Highway Development Control Consultation Response

Planning Application Ref: PL/2025/09200

Site Address: 49, 51 & 53 (Rowden Hill House), Rowden Hill, Chippenham

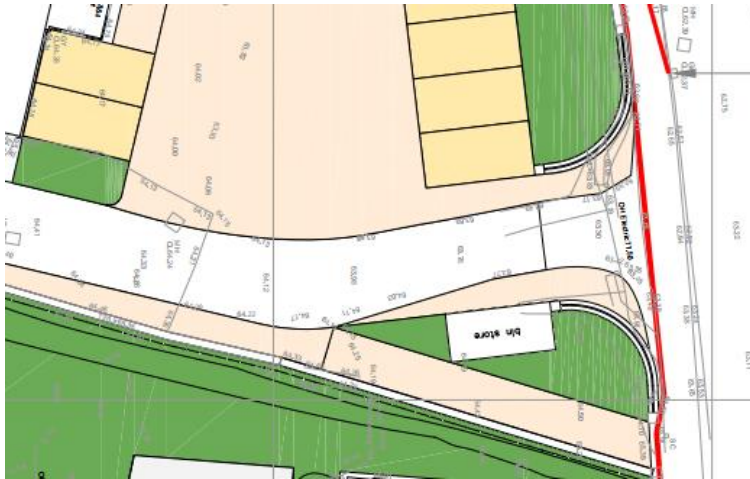
The access arrangement shows tracking for a large service vehicle from the A4 adjacent to the parking area allocated for the renovated 53 Rowden Hill. There is some confusion as to the status of the area in buff between the retained wall at the access, see the snip of the plan here.

This forms part of the overrun area in the waste vehicle tracking diagram. Is this area to be pedestrian use with vehicle overrun? Could the access be widened and the southern wall removed?
